Project 717

Subject: **Response to Request for Additional Information (RAI) numbers (117.2, 306, 314.1, 322, 323.4, 329, and 406) for ESBWR Pre-application Review - Supplementary Information**

Response to NRC RAI numbers (117.2, 306, 314.1, 322, 323.4,
329, and 406) – Supplementary Information

Supplementary Information for RAI 117.2

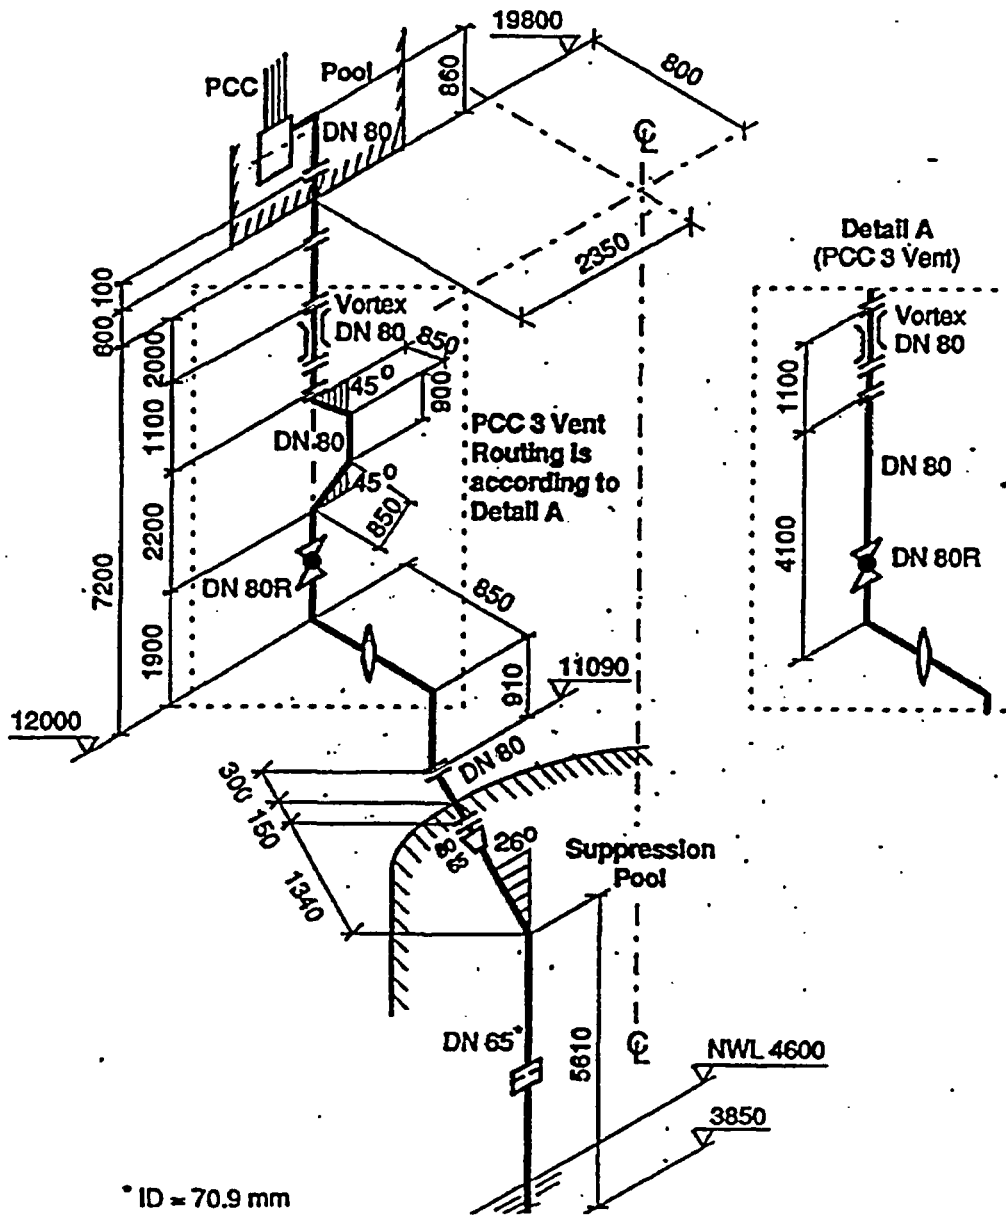
PCC Vent Pressure Tap – Located on downstream side of vortex flow meter

Question:
PCCS Performance During Blowdown

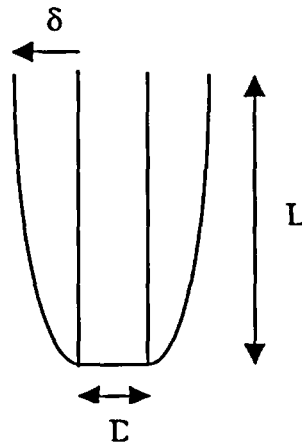
In response to RAI 314.1, it was stated that the PCCS removes about 15% of the blowdown energy. In response to RAIs 335 and 340, it was stated that the PCCS vent submergence is deep enough to avoid stratification but not so deep that it stops the vent function.

1. Provide a road map locating the source of data that demonstrates the PCCS performance (to condensing steam) during the blowdown portion of the event. Under these conditions (flow rates, steam and noncondensable fractions) will the PCCS condense 100% of the steam?
2. If the PCCS cannot condense 100% of the steam, provide a road map locating the source of the data that demonstrates that the PCCS vent submergence is low enough to condense the steam in the suppression pool, such that only noncondensable gases enter the wetwell.

1 The attached Figure 1 shows the flow rates through the PCCS calculated by TRACG for the first 2000 seconds of the transient. The flow is for 3 PCC units lumped into one in the TRACG model. Hence the flow per PCC is the flow shown in the figure divided by 3. Most of the flow in this phase flows through the main vents. The PCC flow varies from approximately [[]]. Figure 2 shows the noncondensable partial pressure at the PCC inlet during the same time period. After clearing out the noncondensibles above the steam line break location in the first couple of seconds, the flow is essentially all steam until 10 minutes into the transient. The flow rate of [[]] is within the test database of the PANTHERS tests. At PANTHERS, a full SBWR-scale PCC unit was tested over a steam flow range between [[]]. Steam-air tests were also conducted over the same steam flow range combined with an air flow range of [[]] (Table A.3-2 of ESBWR TAPD, NEDC-33079P). The ESBWR PCC has similar dimensions but has [[]] tubes. The steam only tests were conducted allowing the PCC pressure to adjust such that all the incoming steam was condensed. Figure 4.1-14 in NEDC-32725P, TRACG Qualification for SBWR, Vol. 1, shows that TRACG calculated the required pressure to condense the steam flow conservatively. (The data point on the right side of the figure corresponds to a steam flow rate of [[]]). Figure 1 also shows that a part of the steam flowing through the PCCs is not condensed. The uncondensed steam flow drops from [[]] to a small value at 300s. Beyond this time, a combination of increase

in PCC pressure and reducing steam flow through the PCCs allows the PCC condensing capacity to catch up with steam flow.
